Appendix 2: Comments

By letter dated October 28, 2024, the U.S. Nuclear Regulatory Commission (NRC) staff, in coordination with the U.S. Department of Energy (DOE), U.S. Environmental Protection Agency (EPA), and New Mexico Environment Department (NMED)¹, agreed to conduct an audit of Homestake Mining Company of California (HMC's) groundwater model (ML24176A247), submitted as part of HMC's 2022 Alternate Concentration Limit (ACL) License Amendment Request (LAR) (ML22263A299). The agencies developed an audit plan consistent with NRC's Licensing Process 111, Rev. 1 Regulatory Audits ([ML25031A057](#)) which included the objectives of the audit. The audit plan also called for a summary report to be prepared at the conclusion of the audit.

Figure 1 . Observed uranium concentration along primary flow path

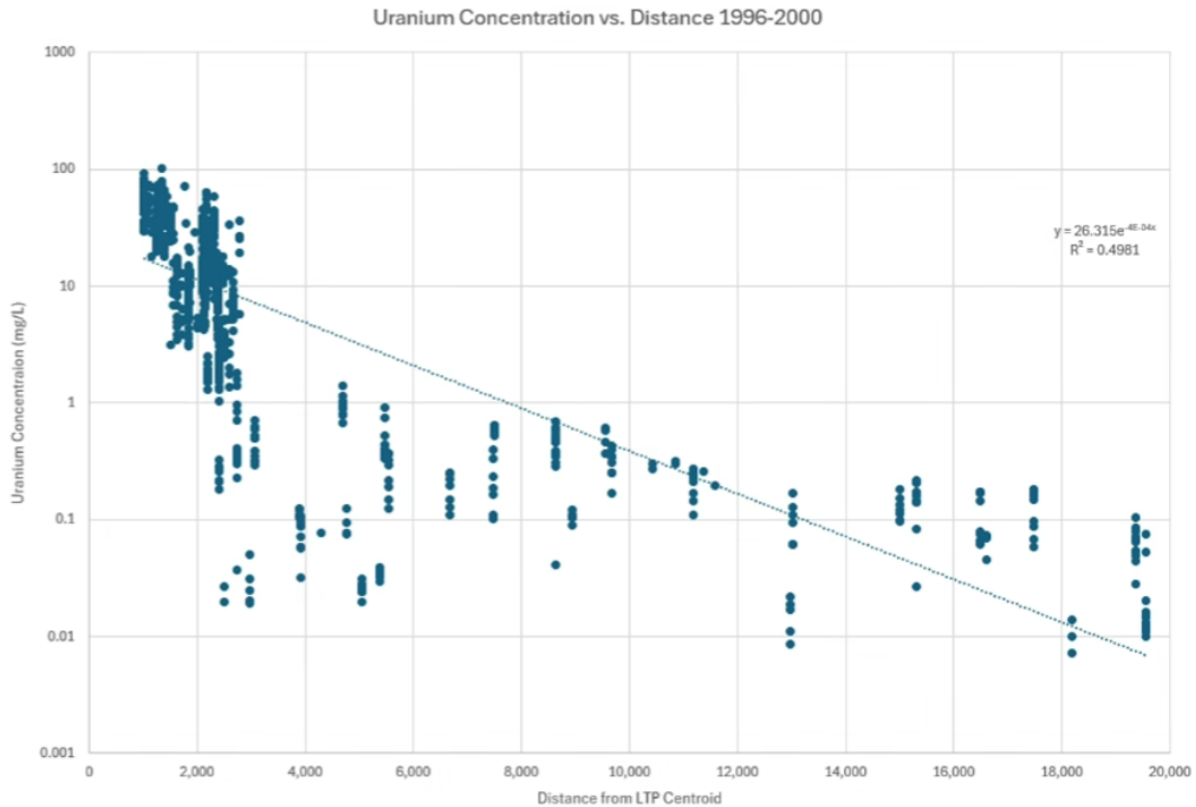
The audit team noted that Figure 1 appears to show different mechanisms resulting in contaminant attenuation. First, there is a grouping of monitoring data with elevated concentrations in the vicinity of the LTP followed by a second grouping of monitoring data with a decreased slope. This is shown in Figure 2 by the separation of data points approximately 3000 ft downgradient from the LTP centroid. The audit team hypothesized that this decrease in uranium concentrations is due to plume cutoff from the hydraulic barrier in the immediate vicinity of the LTP followed by a more gradual attenuation of uranium downgradient from the hydraulic barrier. Staff noted that the historic attenuation of approximately 3 orders of magnitude observed in the vicinity of the LTP will not be nearly as significant without the ongoing corrective actions. In other words, without corrective actions, the plume could migrate at elevated concentrations (i.e., the plume could migrate at concentrations greater than currently observed). The audit team also noted that some of the apparent attenuation may be due to the center of mass of the plume having not yet reached the subcrop area. The audit team asserted this is consistent with monitoring well data (e.g., wells 553, 554, 649) in the vicinity of subcrop area recently showing increasing contaminant concentrations. HMC noted that of these three wells, only 649 had recent data more recent than 2017, and it showed a generally stable trend over the last decade. HMC also noted that wells with more recent data in the general vicinity showed either a decreasing or stable trend over the last decade as well.

The audit team noted that the compilation of uranium concentration monitoring data is informative; however, more information and insights may be required to understand the mechanisms for the observations. The proposed ACL LAR review is expected to include a revised groundwater model and the staff will evaluate support for key assumptions.

Figure 4. HMC's LTP Draindown Model calibration, prediction, and observations

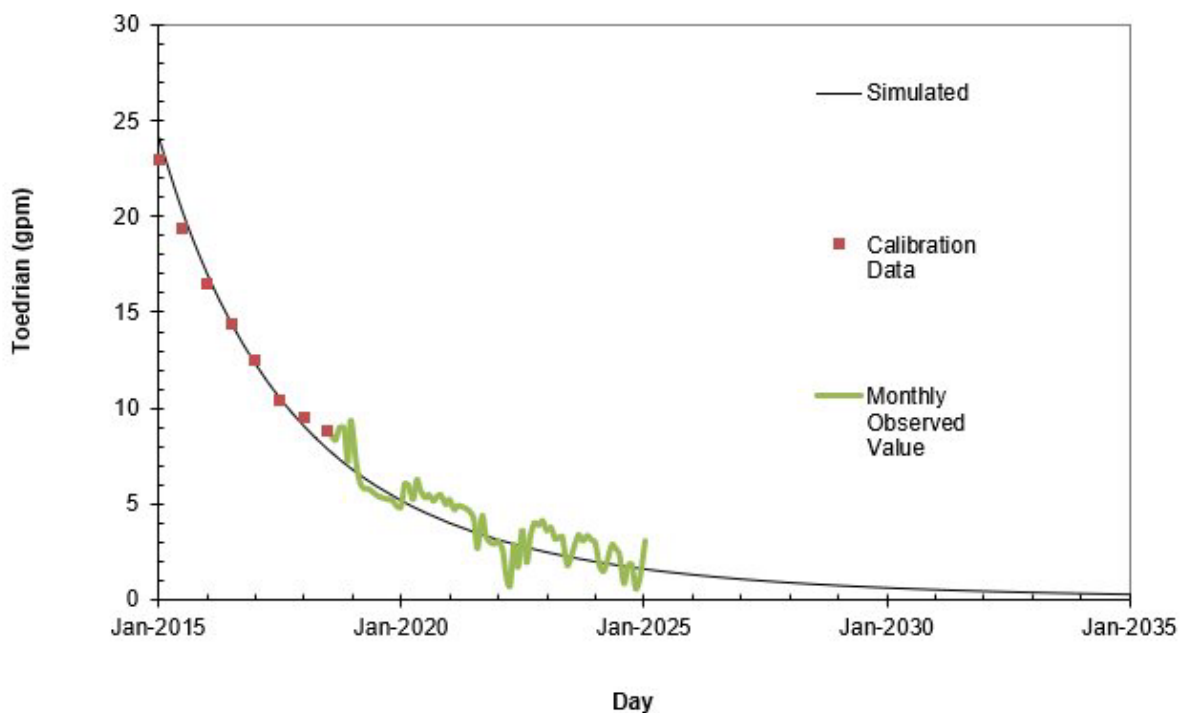
15. Comment: The existing model's seepage rates are based on the DDM, which uses historical data but does not incorporate field-measured rates or spatial variability in drainage behavior. The audit team questioned why the actual spatial distribution of uranium and molybdenum concentrations are not used instead of averaging the concentrations across the LTP footprint. In addition, there does not appear to be any contaminant concentrations added to recharge below the STP.

The uranium and molybdenum concentrations in recharge to groundwater below the LTP are spatially assigned as one average concentration (albeit variable with time). Through 2019, actual uranium and molybdenum concentrations in tailings wells are available (see Figure 46 for uranium in Worthington Miller Environmental 2020).

Homestake presented draindown model predictions developed in 2018 with the observed flowrates from the LTP sumps through 2025 (see Figure 4) and stated that the data demonstrates the model is providing a reasonable estimation of draindown of the LTP.

In addition, HMC noted that they are revising the model and expect to incorporate updated estimates of recharge through the LTP based upon the unsaturated flow modeling done in support of the Evapotranspiration Cover Design Report. HMC noted while spatial variability of concentrations in the LTP could be used to spatially vary the source term, given the

tortuous flow path from the bottom of the LTP to the saturated alluvium at any given point, the exercise would likely yield little value in long-term predictions of the site.

The updated model could refine seepage estimates using site-specific data, account for differences between slimes and sands, and test for potential higher mass loading scenarios. HMC's approach to this issue in the model revisions will be a part of staff's review.
